Modification Recommended Service Note

DSOS604A - DSO Infiniium S Series 6GHz 4 channel

Serial Numbers: MY00000001 - MY58060101; SG55380101 to SG55380104, SG57500101

The Problem – Under certain circumstances a PLL2 error may occur on the S-series products.

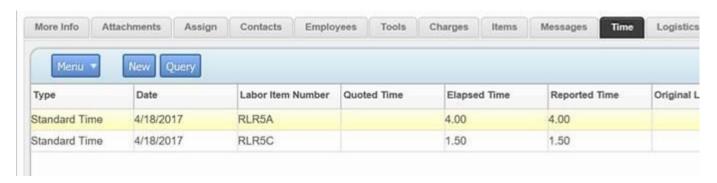
On older acquisition boards a PLL2 error message sometimes occurs. The error message appears on the screen as below:

There are new acquisition boards that fix this issue for the S-series scopes.

Please, use the 54911-69511 board until is gone. If you have a 54911-69511, then skip steps 1 and 2 and proceed to step 3. If there are no 54911-69511, then start with step 1 below.

- 1. If the customer needs to have software revision < 6.10.01001, then replace the acquisition board with the 54911-69532 board.
- 2. If the customer can have software revision >= 6.10.01001, then it can be replaced by any of these three boards: 54911-69521, 54911-69531, or 54911-69532.
